City of Portland, Maine – Building or Use Permit Application 389 Congress Street, 04101, Tel: (207) 874-8703, FAX: 874-8716

FIRE CODE PERMIT REPORT

DATE: 1/5/81 ADDRESS: 1832 Forest Ave
 PERMIT TO: Suburban Program
 OWNER/CONTRACTOR: James Redway
 APPROVED ✓ DENIED _____

FOREST AVE

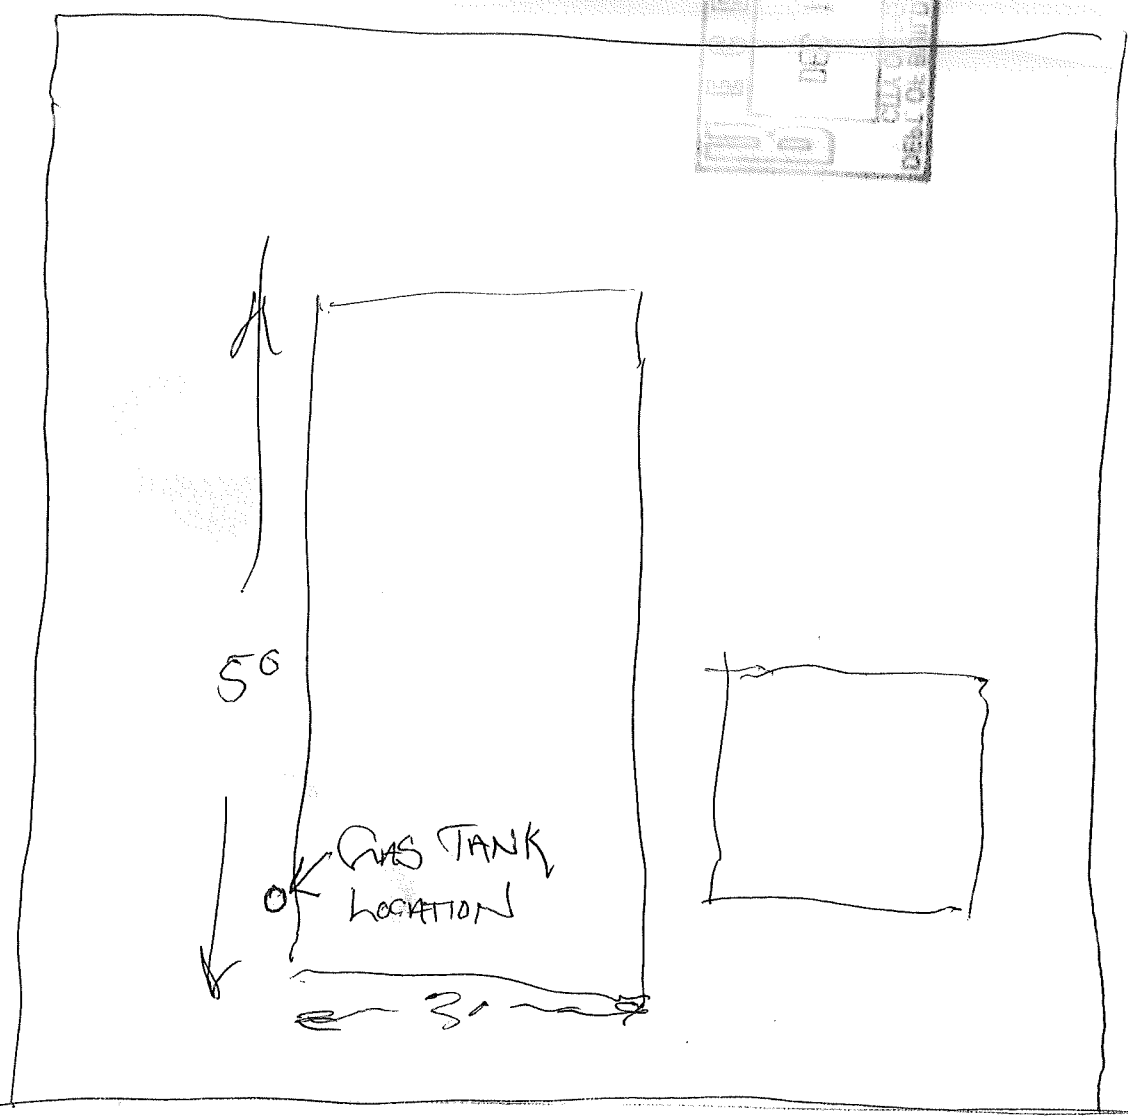
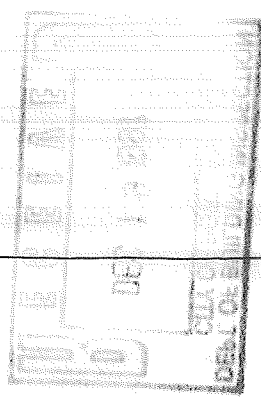
8. All underground tank removal(s) and/or installation(s) shall be done in accordance with the Department of Environmental Regulations (Chapter 691).
9. No cutting of tanks on site. Cutting of tanks is to be done at an approved tank disposal site.

10. Fire Dispatcher must be at least 48 hours in advance of removal and/or transportation of tanks.
11. All above ground L/P storage tanks shall be located in accordance with NFPA 53 Standards.

12. Any tank located near the path of vehicle movement shall be protected with appropriate permanent barricades.
